SUBMITTAL SUMMARY REPORT ImprovePln-000742-2026

PLAN NAME: Oak Shores Estates	LOCATION:
APPLICATION DATE: 05/06/2026	PARCEL: 9064-0000-02
DESCRIPTION: Oak Shores Estates

Oak Shores Estates
#ImprovePln-000742-2026

Development Review Committee Waiver Request Form

6.12.9. (H) - Subdivision roads and related infrastructure

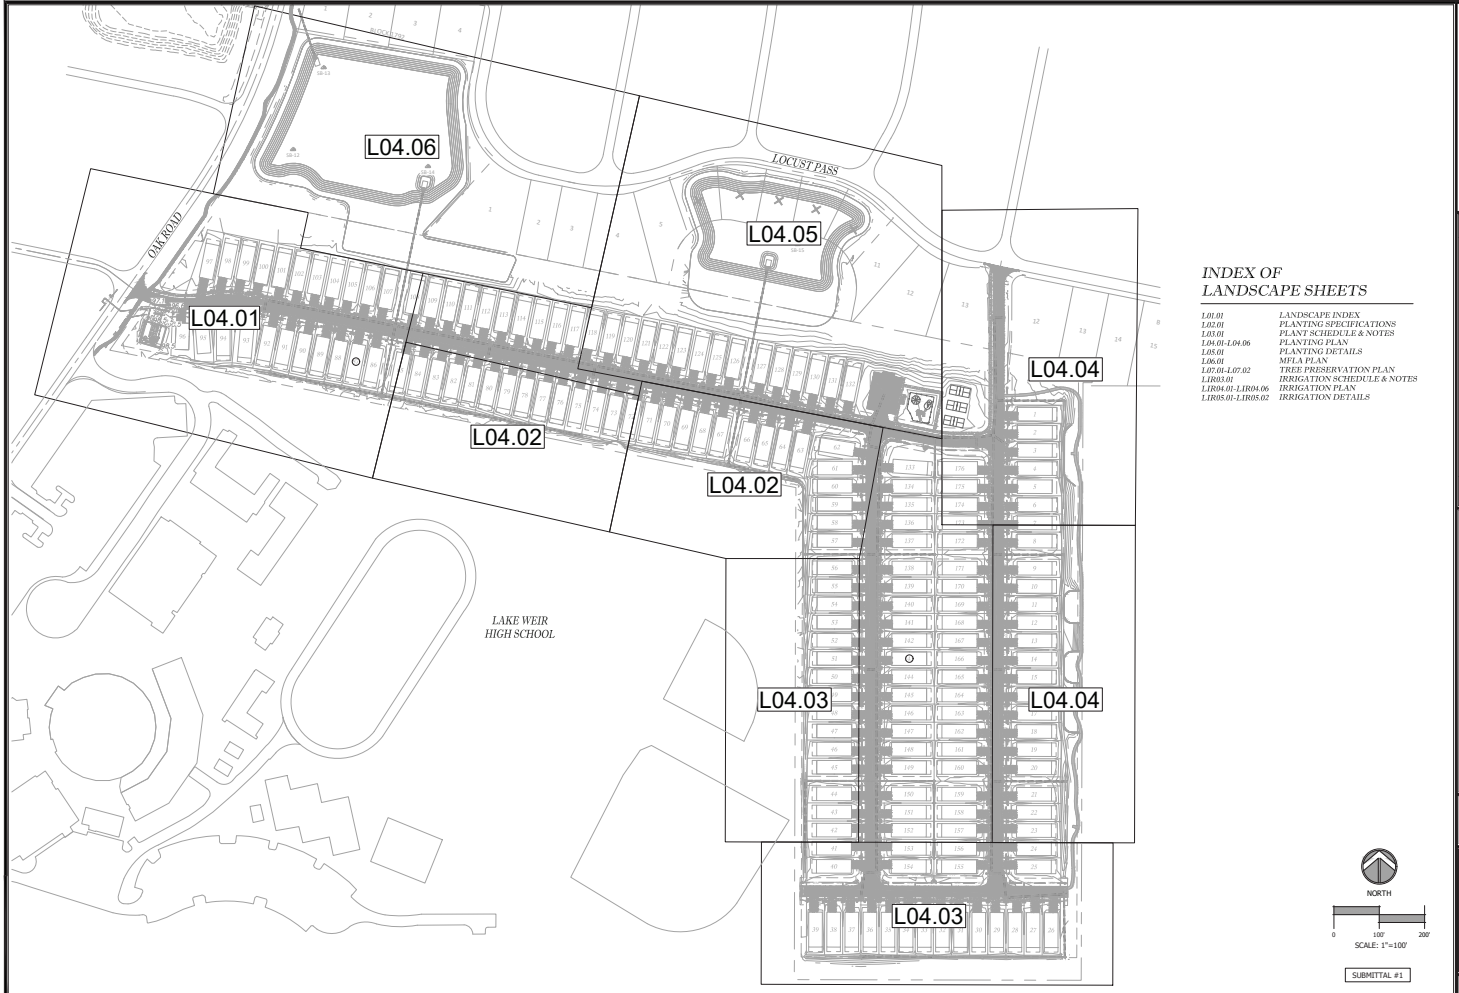
CODE states (H) Dead end roads shall not exceed 1,500 feet and shall have a cul-de-sac at the terminal end. Refer to details in Section 7.3.1. Dead end roads intended to provide future access to adjacent unplatted areas may be permitted without a cul-de-sac provided that no lots front thereon, the length does not exceed 1,500 feet, and appropriate temporary end-of-road markers are provided.

Request a waiver to use of a hammerhead style intersection on dead end roads. The proposed dead end segments will be less than 150' in length.
